Re: Comment Letter Regarding Boeing Final RCRA SMOU Corrective Measures Study for DTSC Draft Statement of Basis for SMOU, and DTSC Draft Post-Closure Permit, Santa Susana Field Laboratory, Ventura County, California

SANTA SUSANA FIELD LABORATORY

COMMENTS ON BOEING SURFICIAL MEDIA OPERABLE UNIT CORRECTIVE MEASURES STUDY AND STATEMENT OF BASIS

Figure 1. Cross-Sectional Depiction of SMOU and CFOU

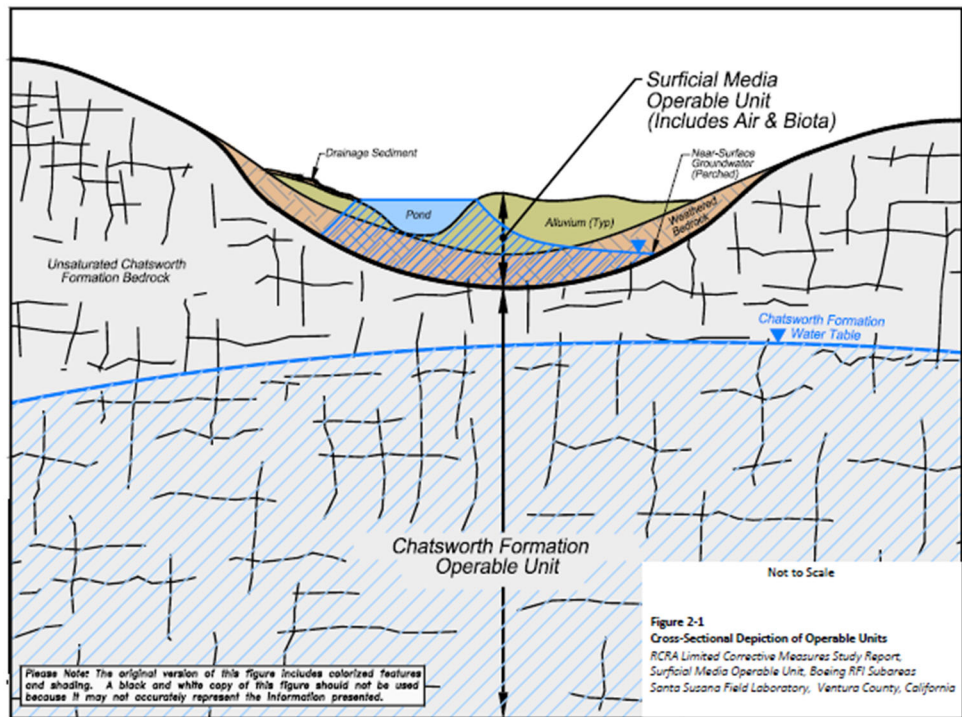
- In Section 2.4.1 of the SMOU CMS Report, Boeing references a cross-section of the SMOU and CFOU that shows shallow perched groundwater. Boeing states that "the CMS Report applies to the soil, sediment, surface water, air, biota, and weathered bedrock within the SMOU in the Boeing RFI subareas of the SSFL, except for near-surface groundwater and seeps and springs, which are addressed in a separate CMS Report for the CFOU."⁸ Figure 1 is the cross-sectional depiction of the SMOU and CFOU.⁹ The CMS language is confusing because the shallow perched groundwater is shown in the figure as part of the SMOU.

DTSC should clarify whether shallow groundwater or near-surface groundwater is covered by the SMOU or the CFOU in the Statement of Basis and ensure the respective operable unit documents address all relevant media.

Figure 2. Excerpted Figure 4-3a1 from SMOU CMS⁴⁵

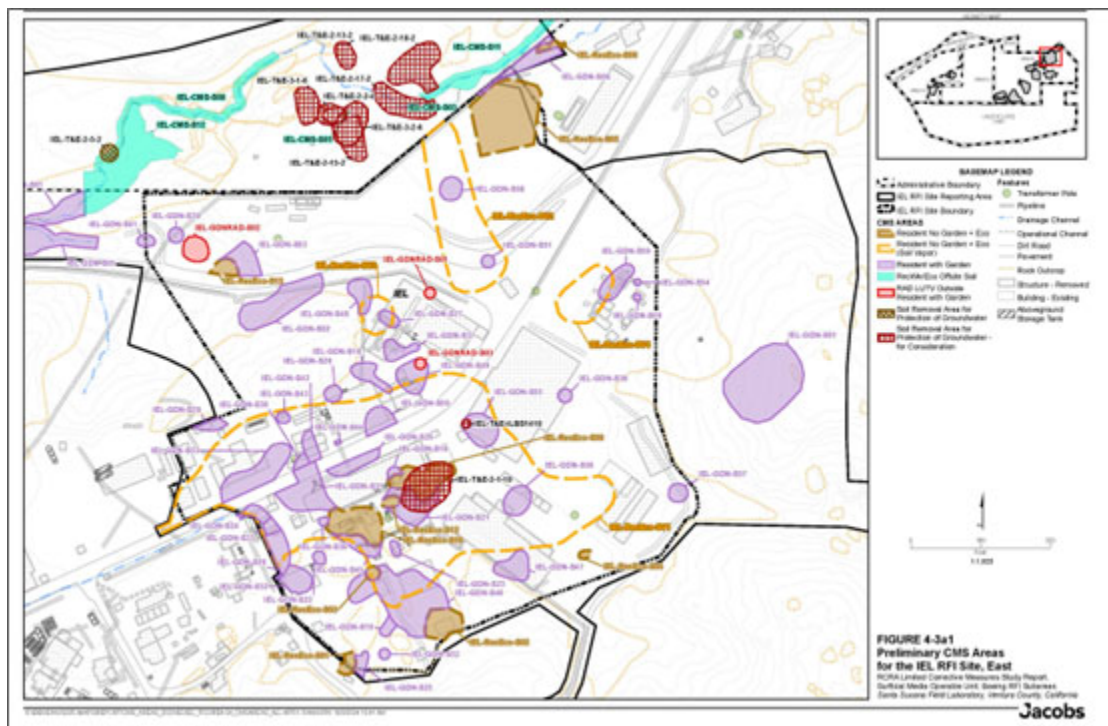
The figures provided in 4-1 through 4-22 of the SMOU CMS raise some questions about how the risk screening criteria are being applied across each RFI. For example, Figure 4-3a1 (excerpted as Figure 2 below) shows the proposed cleanup areas in the Offsite Instrument and Equipment Laboratory (IEL) area and the varying criteria that apply. This represents approximately 15 acres and within that area, there are over 50 footprints where remedial action is expected. As the figure shows, there are numerous footprints where the cleanup criteria are “Resident with Garden” that are immediately adjacent to, or within 100 feet of, footprints where the cleanup criteria are “Resident no Garden”.

This patchwork approach to cleanup raises questions about the protectiveness of the cleanup and the expected outcome. This was also raised in the October 7, 2025 public meeting where one community member roughly stated:

It will be important for DTSC to ensure that the use of these more conservative criteria continue to be applied to the site cleanup given that Boeing implied that they are not applicable to the “end state” of the property.
